# TECHNICAL BULLETIN

## FUSELAGE AFT SECTION AND TAILBOOM MODIFICATION

Model 600N Helicopters, serial number RN003 thru RN066 and RN068.

Analysis of the lower tailboom attach fittings and the upper longerons indicate that cracks may occur.

**Figure 3. Fuselage Aft Section Modification (Sheet 3 of 5)**

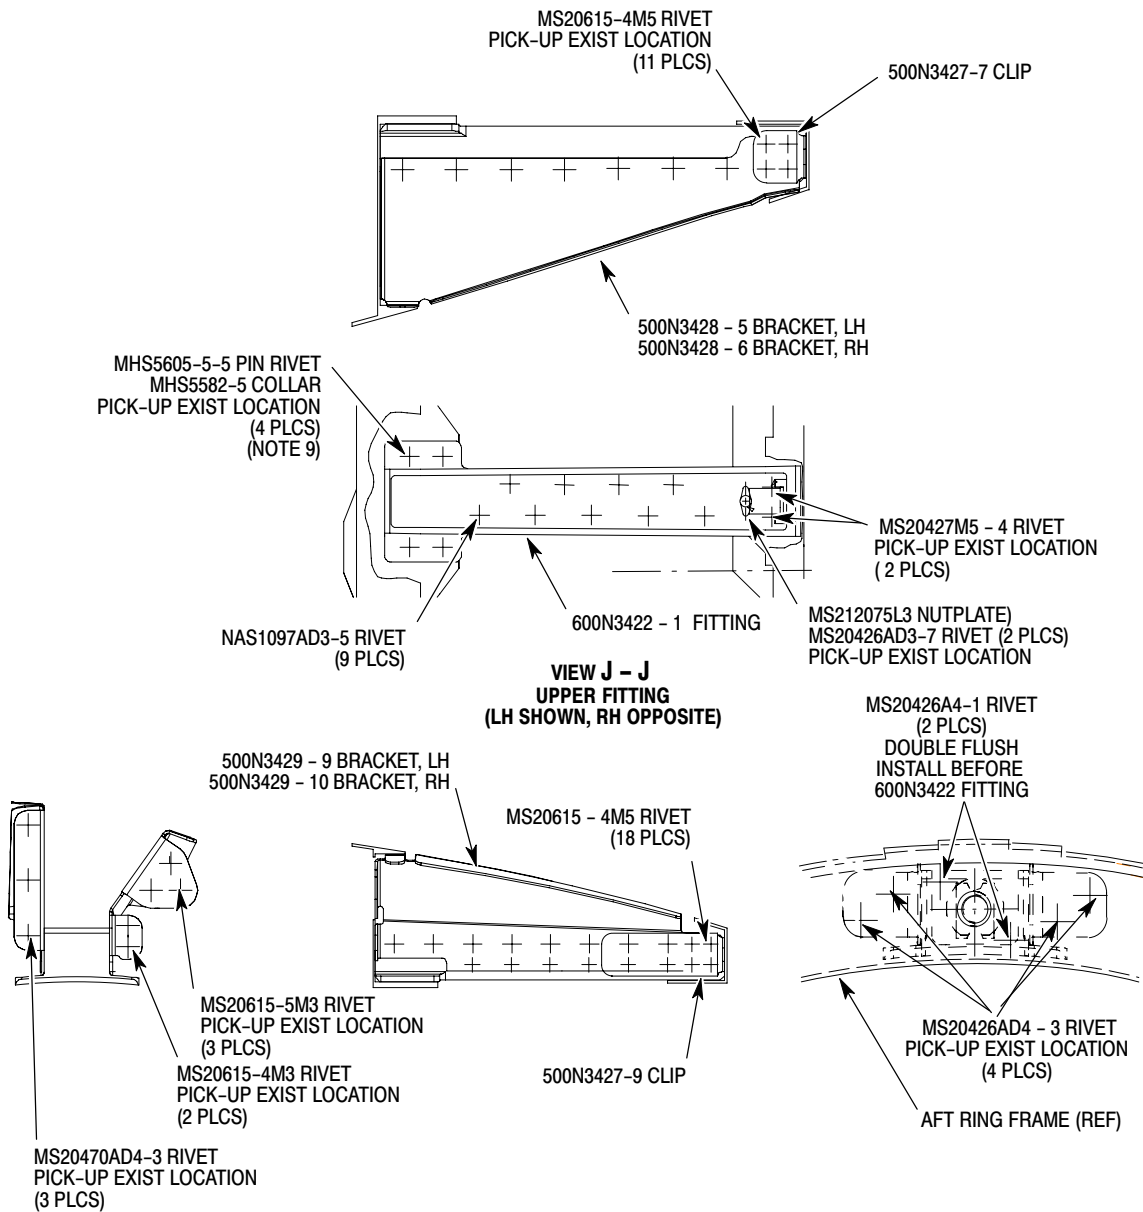
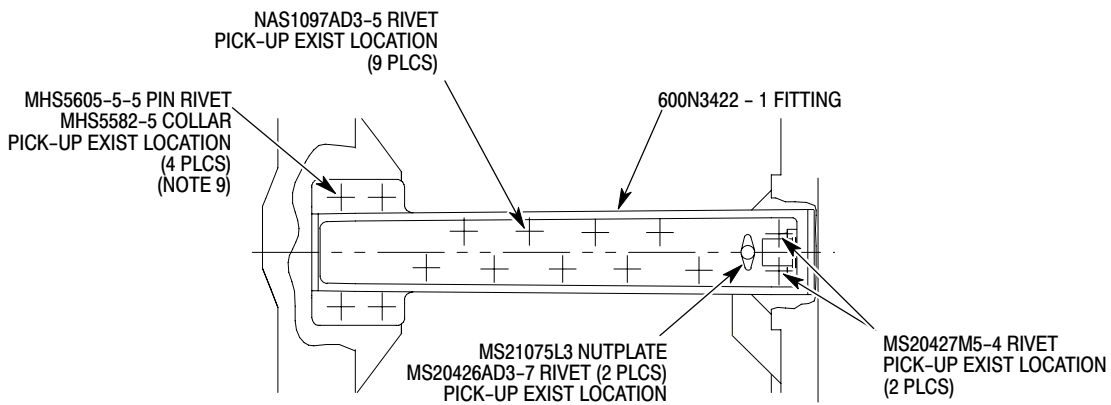
- (8). Position upper tailboom attach fittings. (Ref. View J-J.)
- Touch countersink and double flush install two MS20426A4-1 rivets in holes adjacent to each upper tailboom attach hole in aft ring frame.
  - Position new brackets (P/N 500N3429-9/-10), new fittings (P/N 600N3422-1) and retained brackets (P/N 500N3428-5/-6) between aft ring frame and fan support frame.
  - Position two upper clips (P/N 500N3427-7) and two lower clips (P/N 500N3427-9) and clamp into place.
  - Mark location for all rivet holes on brackets, fittings and clips.
  - Remove brackets, fitting and clips.

- Drill rivet holes in new fitting using drill press.
- Deburr holes and remove all debris.
- Temporarily install clips, brackets and fittings with clecos.
- Match drill tailboom attach bolt hole in aft end of each fitting. (Ref. View L-L.)
- Remove brackets, fitting and clips.
- Deburr holes and remove all debris from fittings.
- Install clips, brackets and fittings with rivets, as shown. (Ref. View J-J.)

**VIEW K - K  
 LOWER FITTING  
 (LH SHOWN, RH OPPOSITE)**

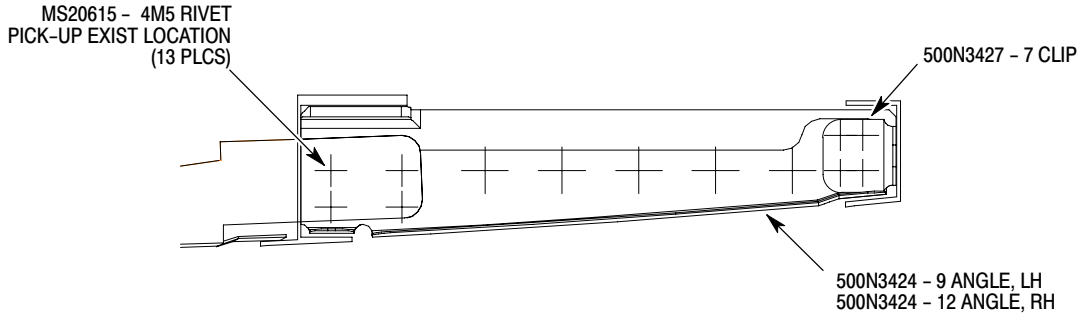
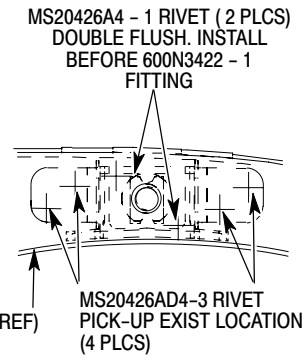
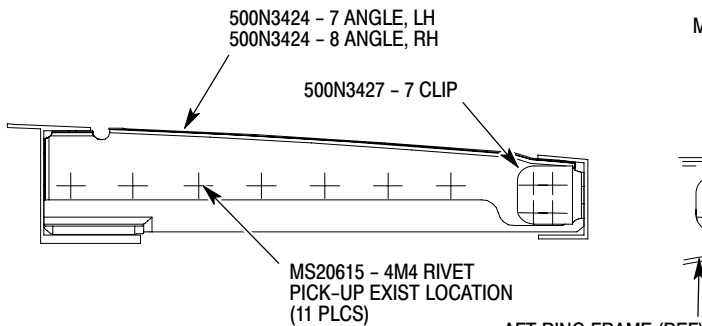
- Install nutplate (P/N MS21075L3) in fitting with rivets, as shown.
- (9). Position lower tailboom attach fittings. (Ref. View K-K.)
- Touch countersink and double flush install two MS20426A4-1 rivets in holes adjacent to each upper tailboom attach hole in aft ring frame.
  - Position new fittings (P/N 600N3422-1) and retained angles (P/N 500N3424-7/-8/-9/-12) between aft ring frame and fan support frame.
  - Position two upper clips (P/N 500N3427-7) and two lower clips (P/N 500N3427-7) and clamp into place.
  - Mark location for all rivet holes on brackets, fittings and clips.
  - Remove brackets, fitting and clips.

- (g). Deburr holes and remove all debris.
- (h). Temporarily install clips, brackets and fittings with clecos.
- (i). Match drill tailboom attach bolt hole in aft end of each fitting. (Ref. View L-L.)
- (j). Remove brackets, fitting and clips.
- (k). Deburr holes and remove all debris from fittings.
- (l). Install clips, brackets and fittings with rivets, as shown. (Ref. View K-K.)

**Figure 3. Fuselage Aft Section Modification (Sheet 5 of 5)**

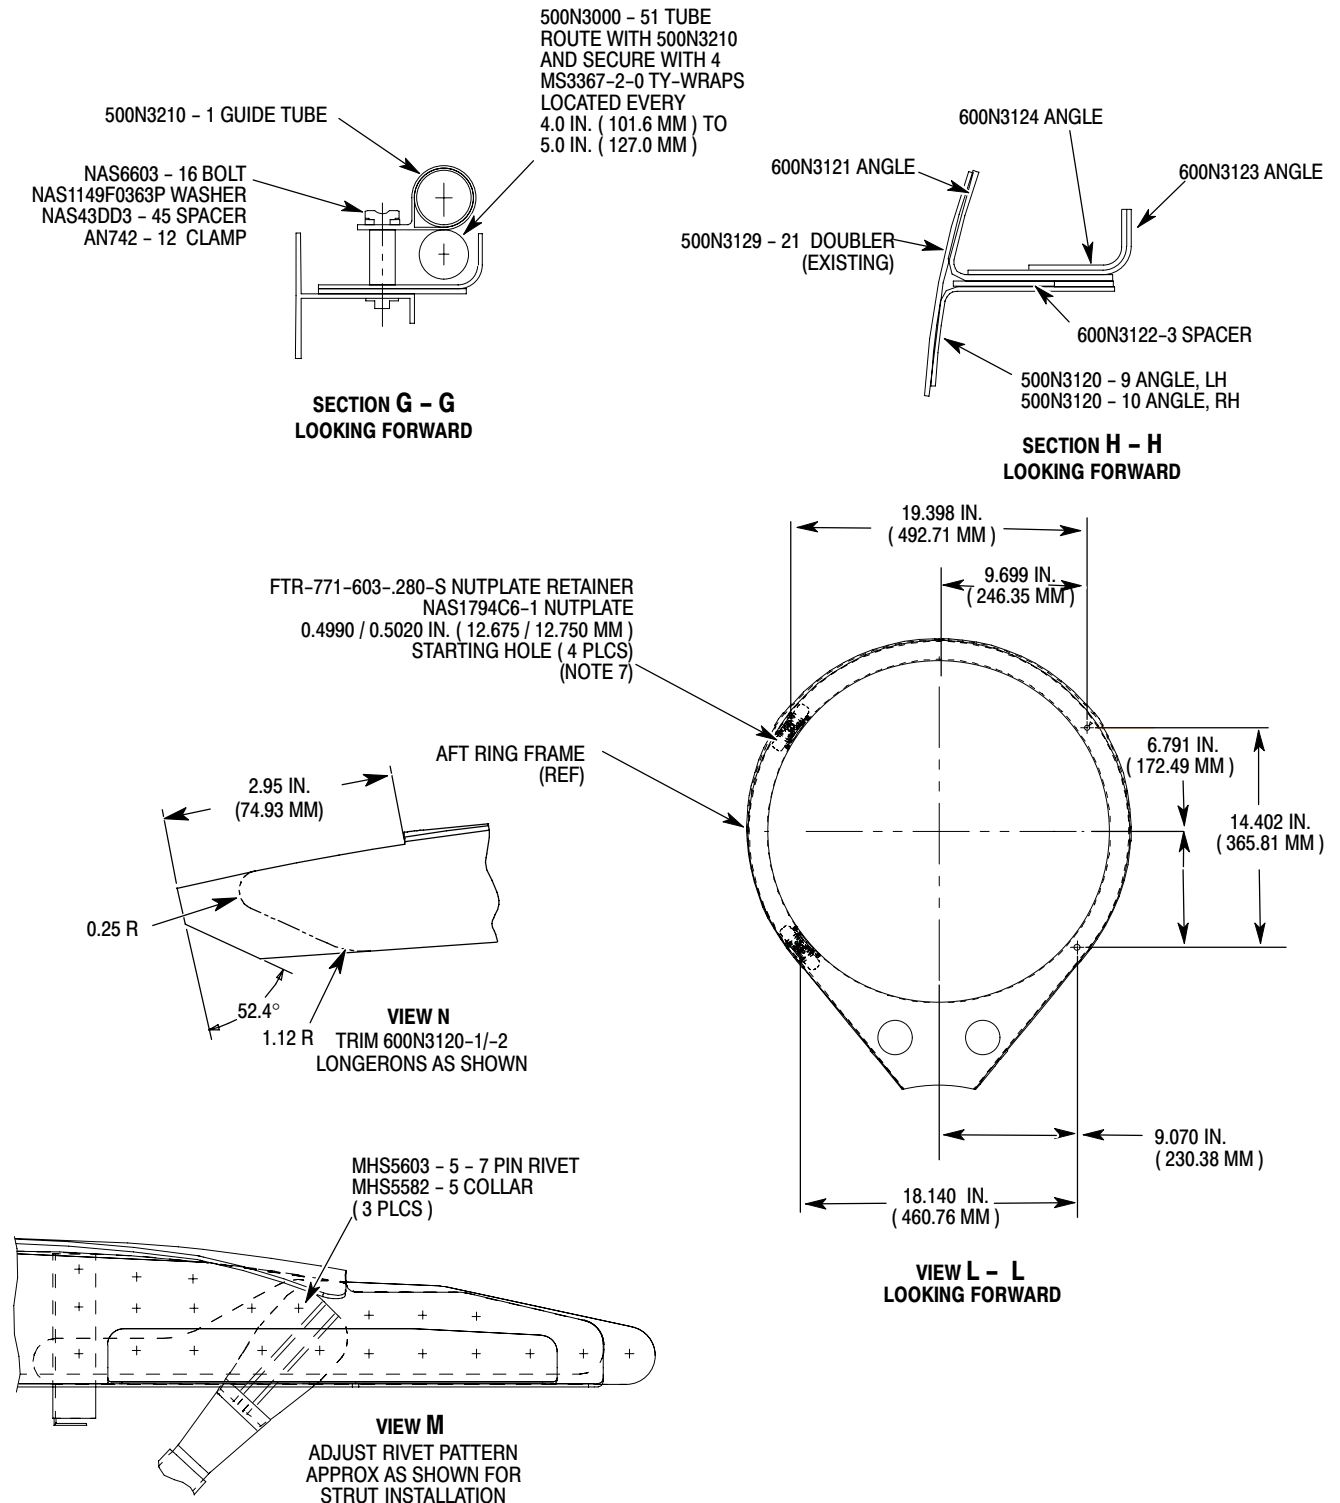
- (13). Install guide tube, as follows. (Ref. Section G-G.)
  - (a). Place guide tube (P/N 500N3210-1) into position.
  - (b). Route tube (P/N 500N3000-51) with guide tube.

- (c). Place clamp on guide tube and secure with one bolt, washer and spacer.
  - (d). Secure tube to guide tube with four ty-wraps, as shown.
- (14). If required, reconnect wires to connectors J208 and J513 (Ref. CSP-HMI-3, Section 96-00-00, Electrical Connectors).

**Figure 4. Fuselage Aft Section Rework and Installation of Parts**

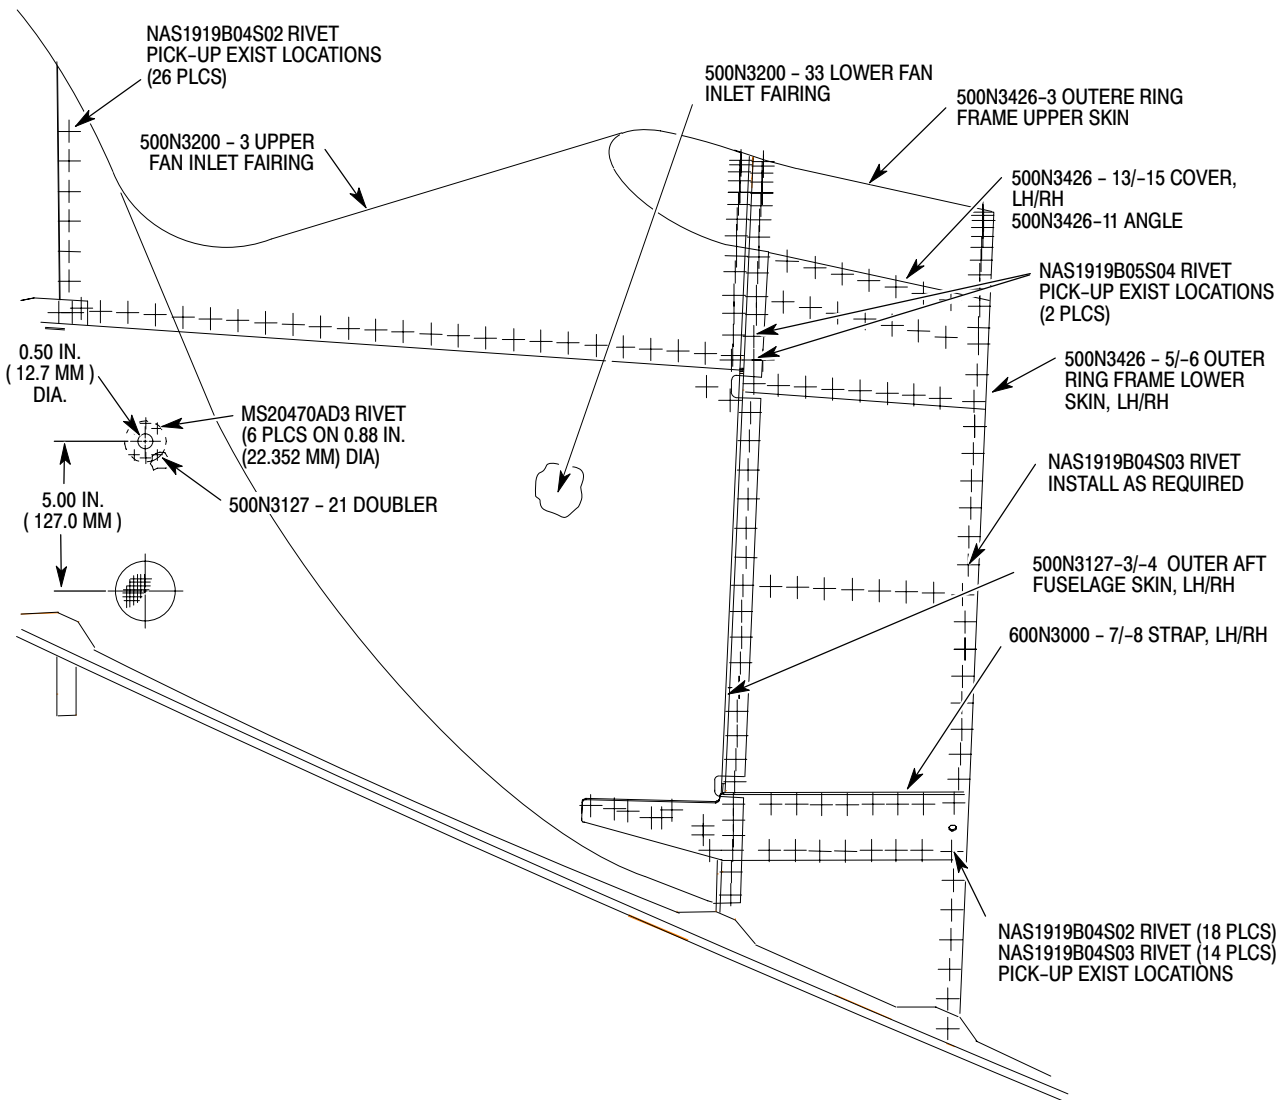
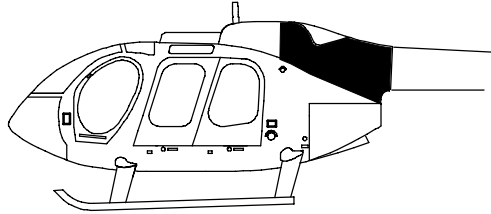
- (15). Install inspection hole.
  - (a). Locate and drill one 0.50 inch (12.7mm) inspection hole (L137) in left side of fuselage.
  - (b). Apply chemical coating and primer to inspection hole per manufacturer's instructions.
  - (c). Install doubler with six MS20470AD3 rivets.

**Figure 5. Tailboom Assembly Rework**

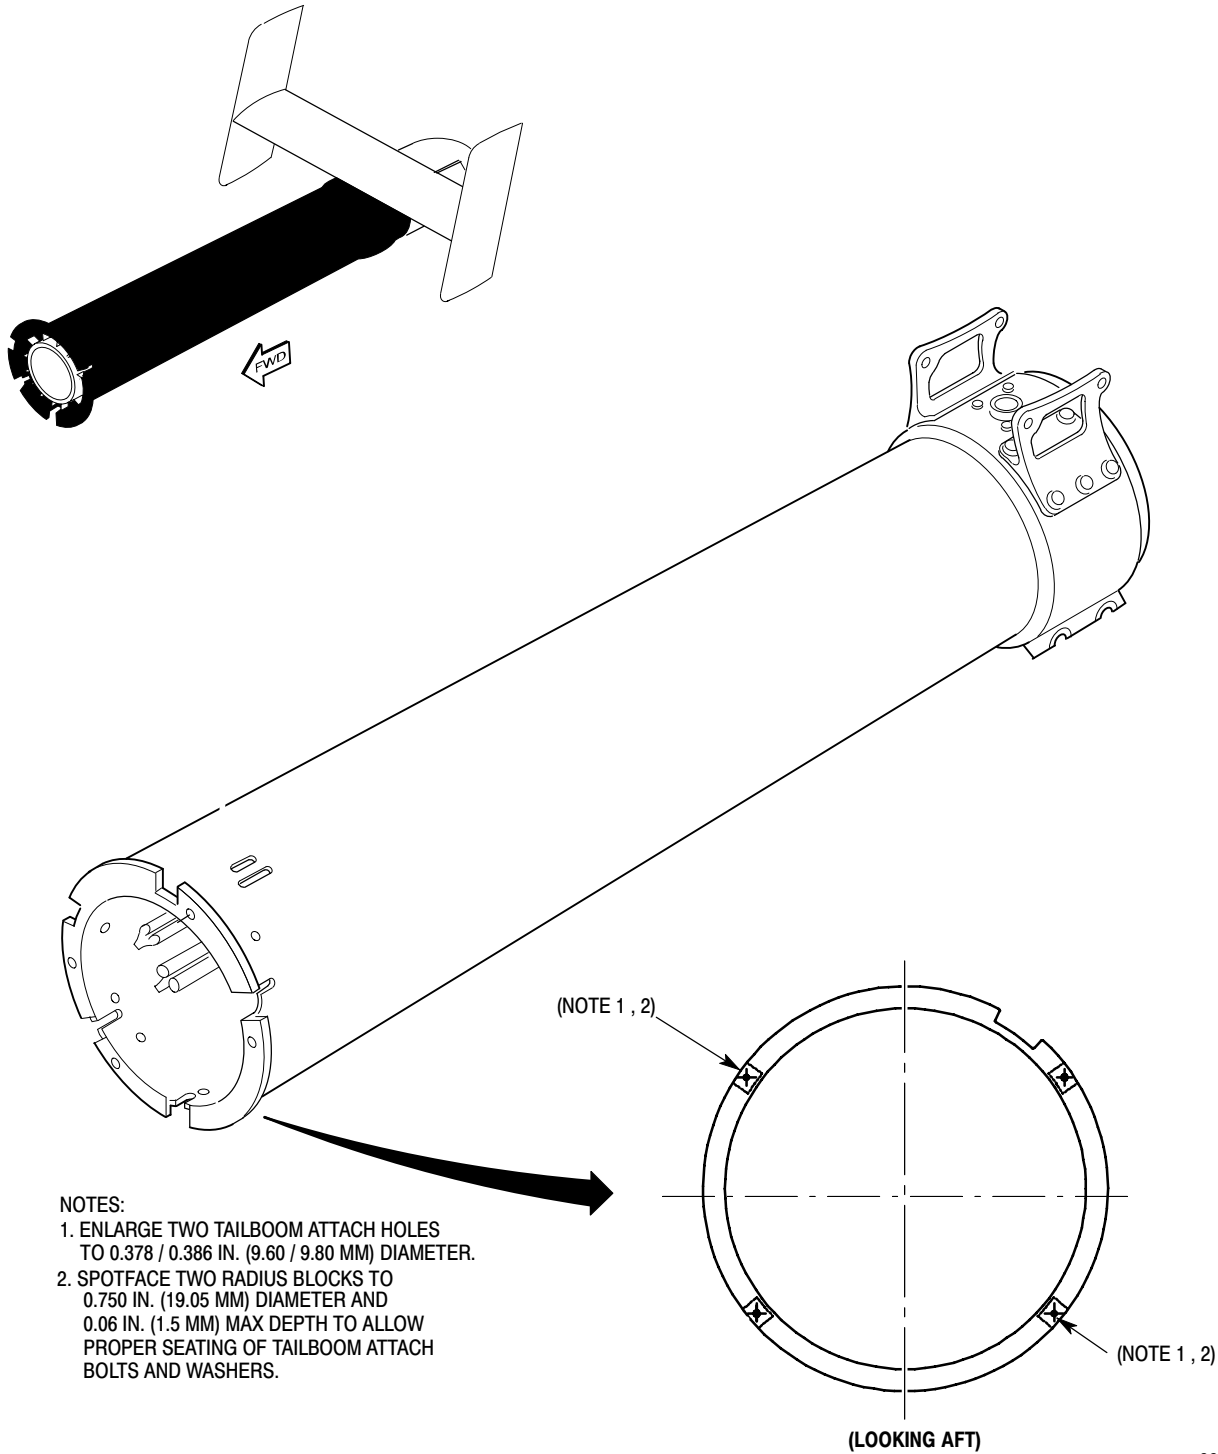
- (a). Using drill fixture 600N3510-1-DJ1, ream two tailboom attach holes to 0.378/0.386 inch (9.60/9.80 mm) and spotface to 0.750 inch (19.05 mm) diameter and 0.06 inch (1.5 mm) maximum depth.
- (b). Apply chemical coating to reworked holes in radius blocks per manufacturer's instructions.
- (c). Reidentify modified tailboom assembly. Pre and post modification part numbers are shown in Table 1).
  - 1). Carefully remove ID plate from tailboom assembly.
  - 2). Clean area where new ID plate will be installed with isopropyl alcohol or acetone.
  - 3). Peel backing off new ID plate and press plate on prepared surface. Roll ID plate with 1 inch (25.4 mm) cylindrical plastic roller.
  - 4). Edge seal ID plate with clear epoxy.

1. ENLARGE TWO TAILBOOM ATTACH HOLES TO 0.378 / 0.386 IN. (9.60 / 9.80 MM) DIAMETER.
2. SPOTFACE TWO RADIUS BLOCKS TO 0.750 IN. (19.05 MM) DIAMETER AND 0.06 IN. (1.5 MM) MAX DEPTH TO ALLOW PROPER SEATING OF TAILBOOM ATTACH BOLTS AND WASHERS.
